02 Elevations

Canal Street

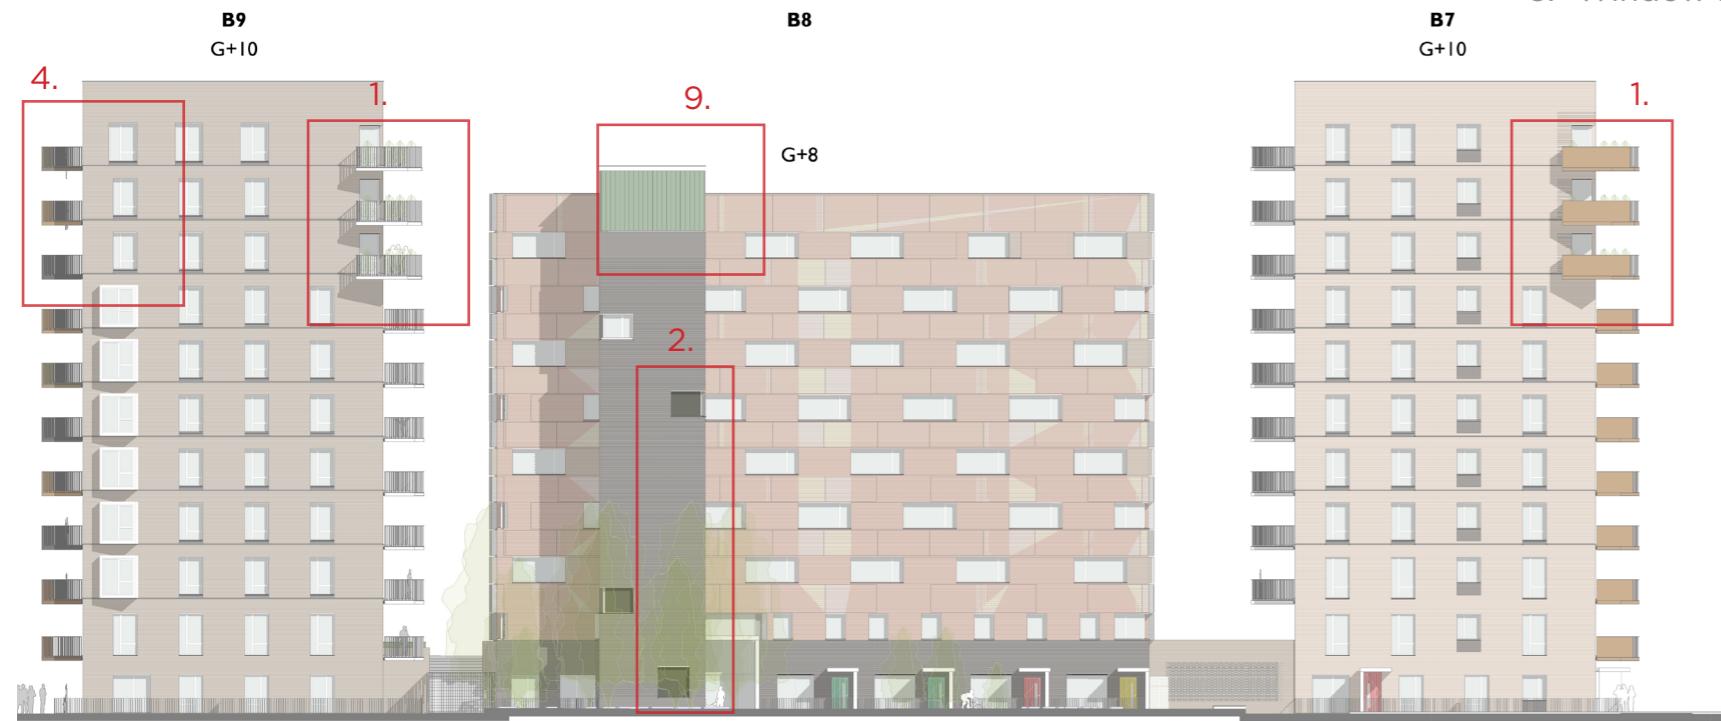
1. Rationalisation of balcony design as per previous phases
2. Windows omitted to suit developed stair/lift core design
3. Rationalisation of apartment stacking to facilitate drainage stacking / co-ordination
4. Window amended to ensure consistency between apartment type layouts
5. Window reduced to avoid internal clashes
6. Rationalisation / standardisation of balcony types
7. Balconies re-sized and linked to ensure compliance to London Plan area standards
8. Window type amended to match adjacent levels
9. Adjustment of architectural articulation

Coffee Park

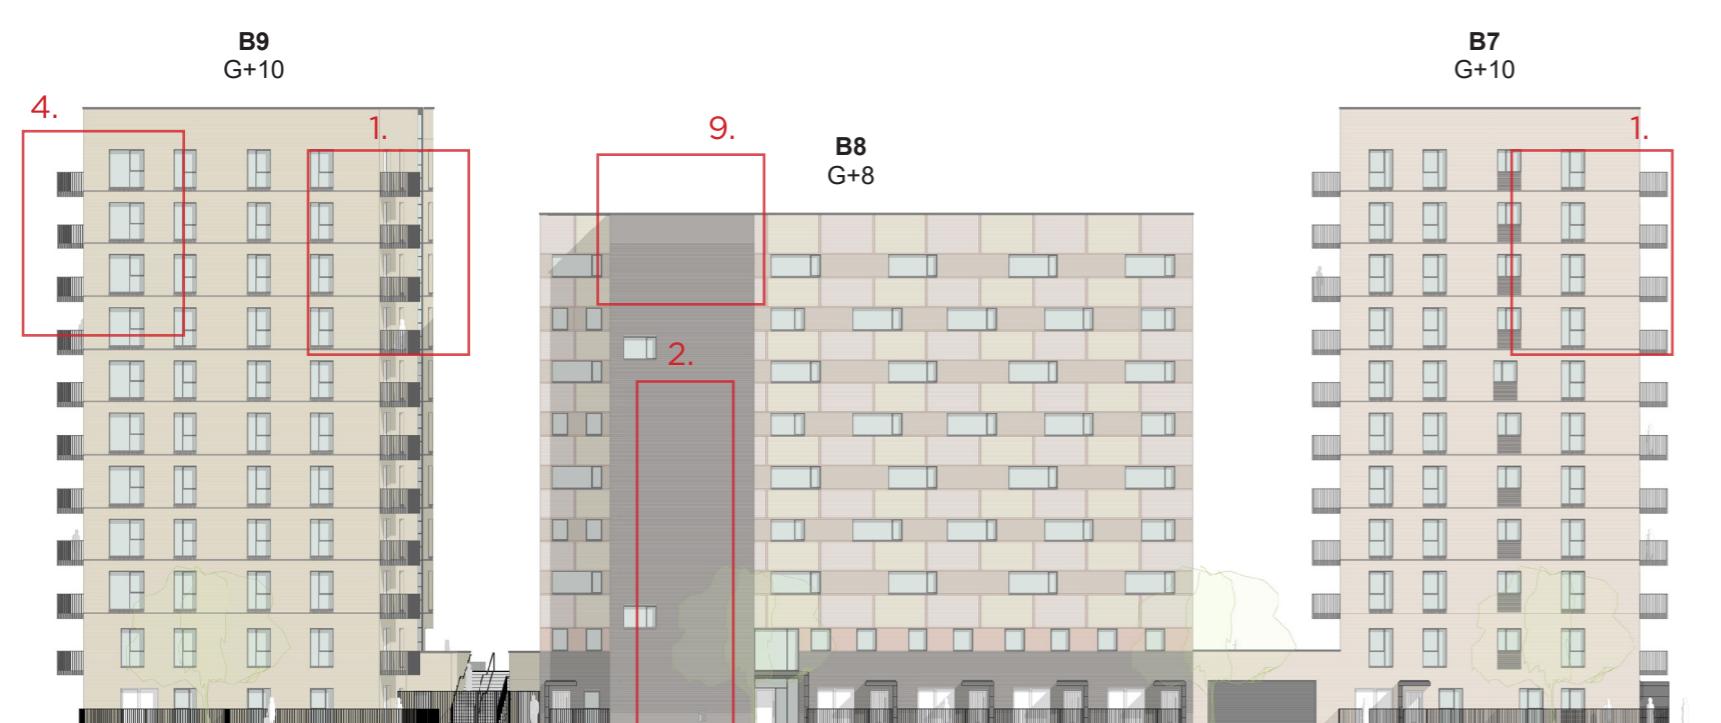
1. Rationalisation of balcony design as per previous phases
2. Windows omitted to suit developed stair/lift core design
3. Rationalisation of apartment stacking to facilitate drainage stacking / co-ordination
4. Window amended to ensure consistency between apartment type layouts
5. Window reduced to avoid internal clashes
6. Rationalisation / standardisation of balcony types
7. Balconies re-sized and linked to ensure compliance to London Plan area standards
8. Window type amended to match adjacent levels
9. Adjustment of architectural articulation
